**PERMIT**  
**INDEXED**  
**SANDMOUND SYSTEM**  
**ON-SITE SEWAGE DISPOSAL SYSTEM**  
**HOWARD COUNTY HEALTH DEPARTMENT**  
**BUREAU OF ENVIRONMENTAL HEALTH**  
*Tax ID # 04-332954*

SUBDIVISION: Brown Property LOT NUMBER: 9C

ADDRESS: 14596 Monticello Dr. PROPERTY OWNER: Charles Brown

BROWN RESIDENCE  
SCALE: 1" = 30'

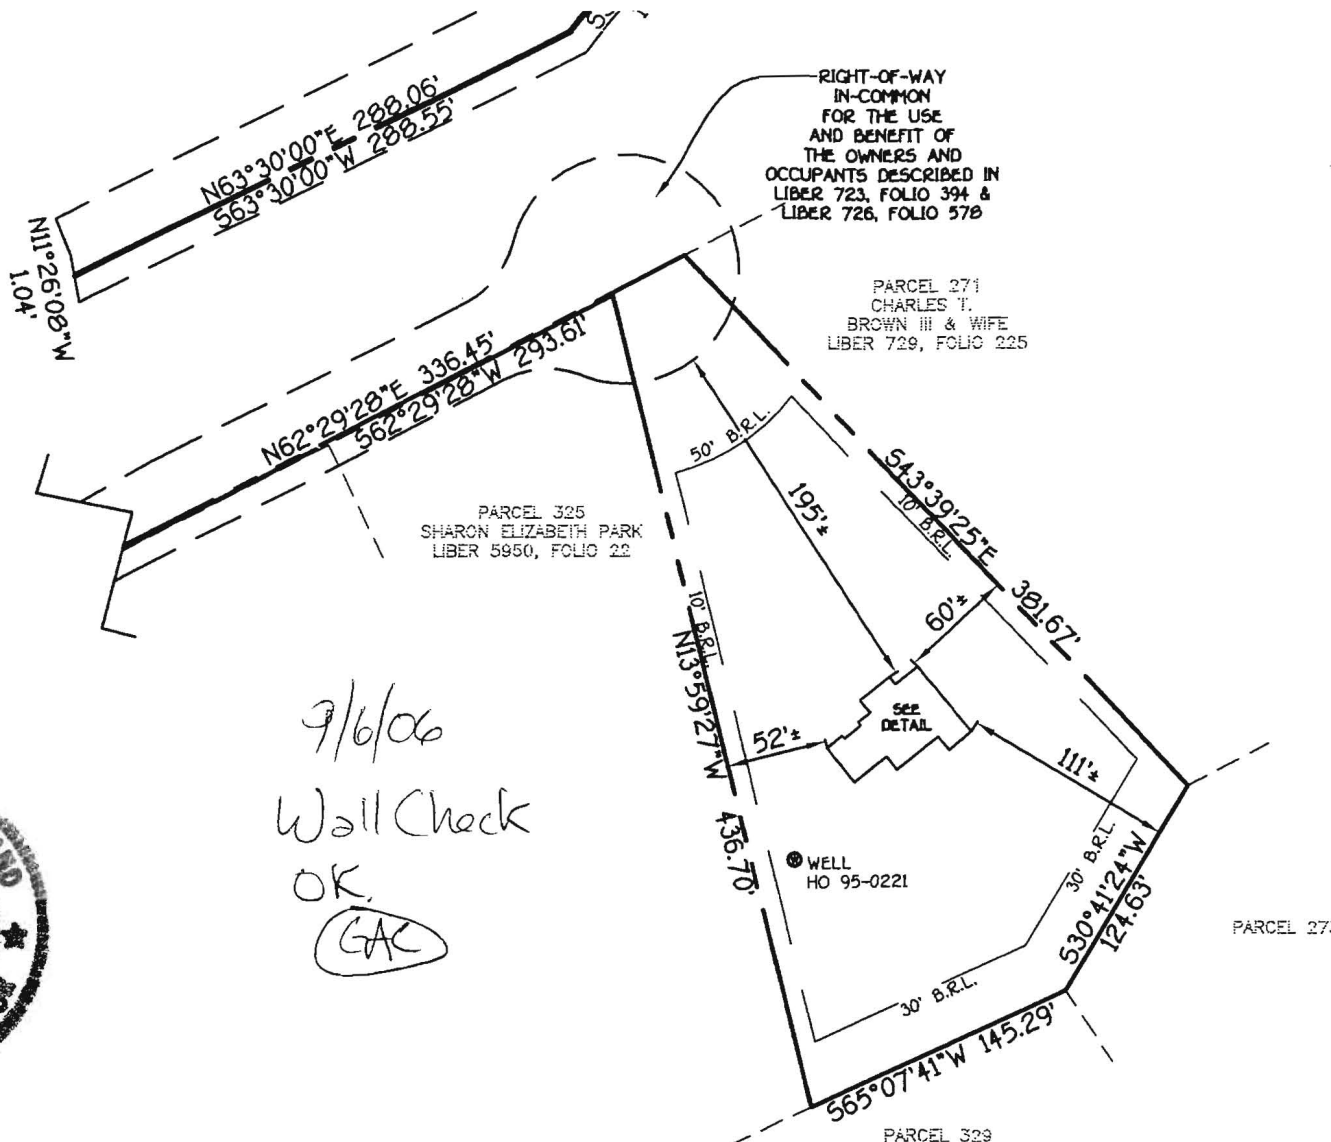
INSTALLATION 10/26/06 Tanks set. Plumbers finished. Need to final grade and seed mound. Grading to be done so that water washes around top of mound. Need pump, alarm and lateral test. (BB) 12/5/06 All laterals have ~2.5' of head. Alarm not on separate breaker. Need to rewire alarm. (BB) 12/6/06 Alarm wired correctly and working (BB)
